30/13-5 11018 Kenilworth Avenue
Garrett Park - Preliminary Consult.

HISTORIC PRESERVATION COMMISSION STAFF REPORT

Review: Preliminary Consultation

PROPOSAL: Alteration/Addition/
Fire Damage Restoration

Proposed Rear

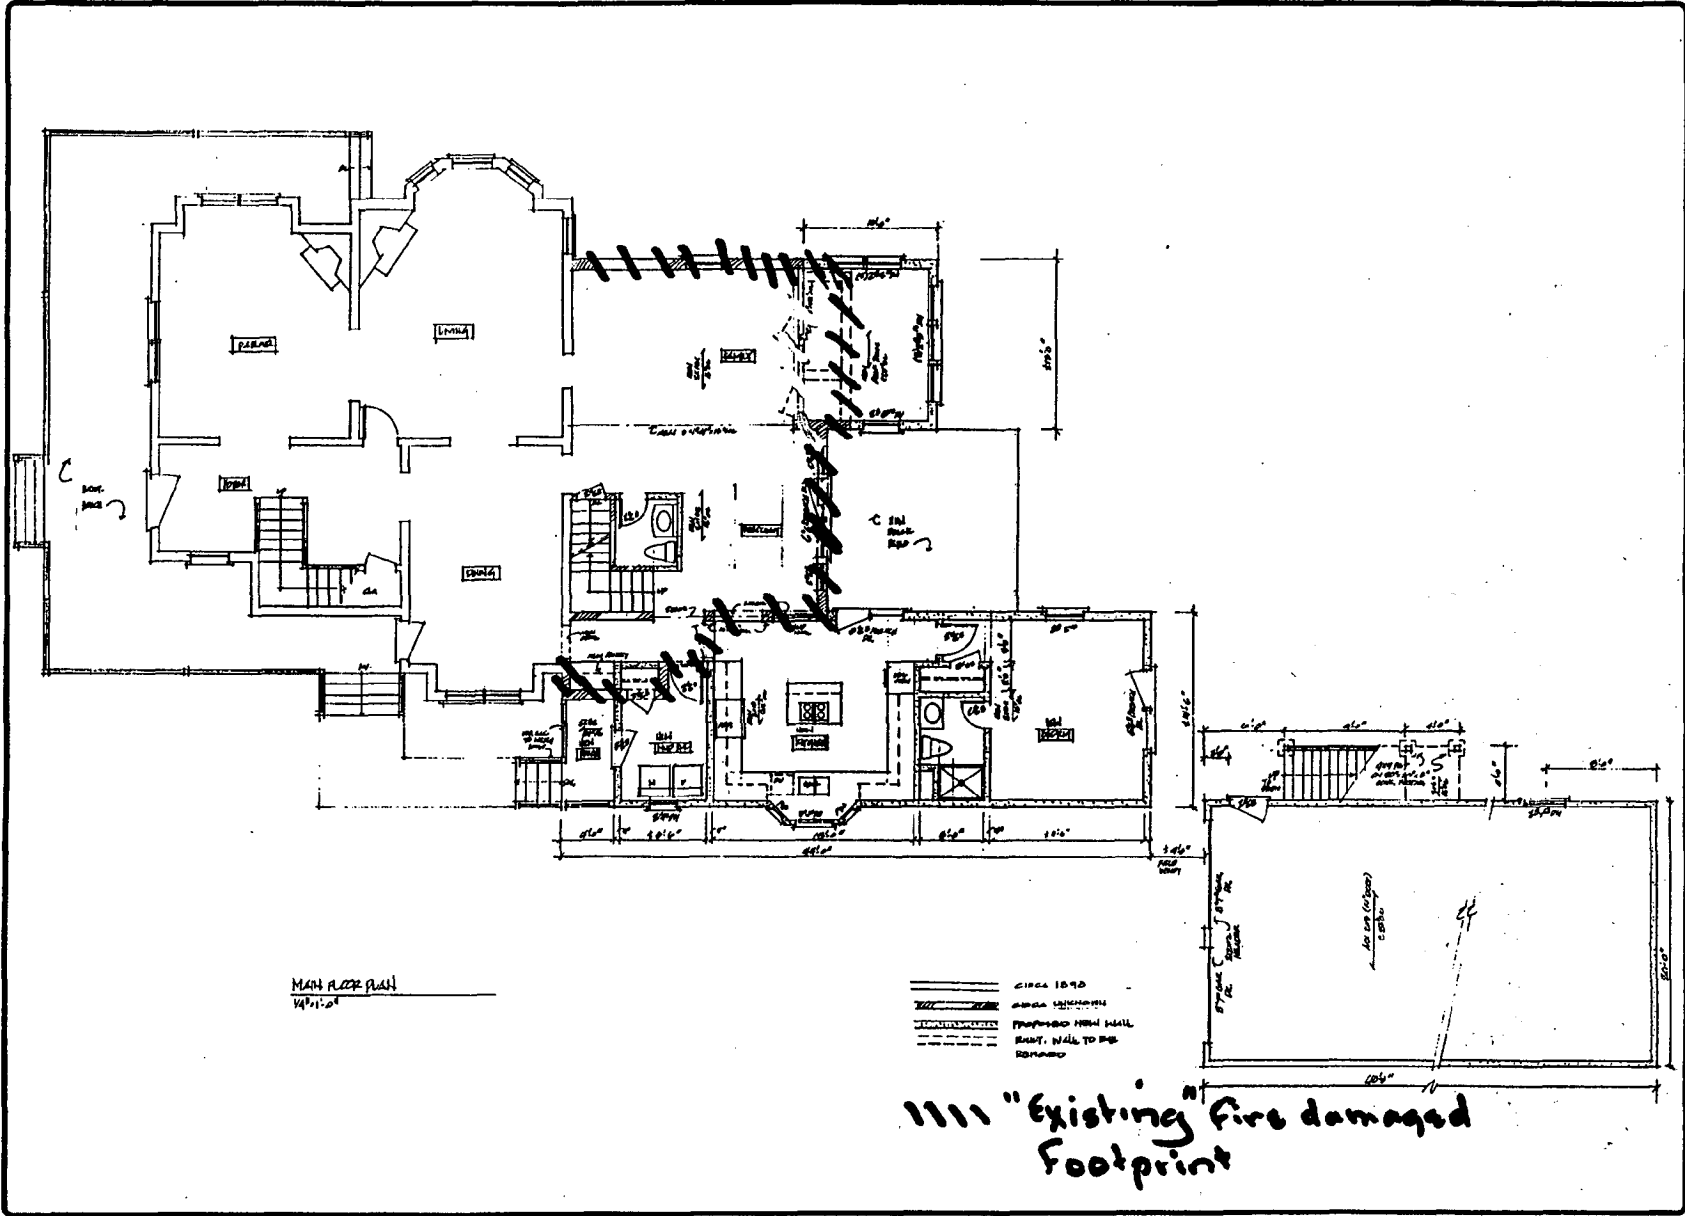
H6 - concern - not major - massing where garage & side addition come together

DH- ok - if can change garage & side addition would be good

SS- ok - could garage go sideways

SP- could garage go further back - there: ¹⁰⁻¹⁵⁾

EE- would like to see what's neighboring - ^{footprint}
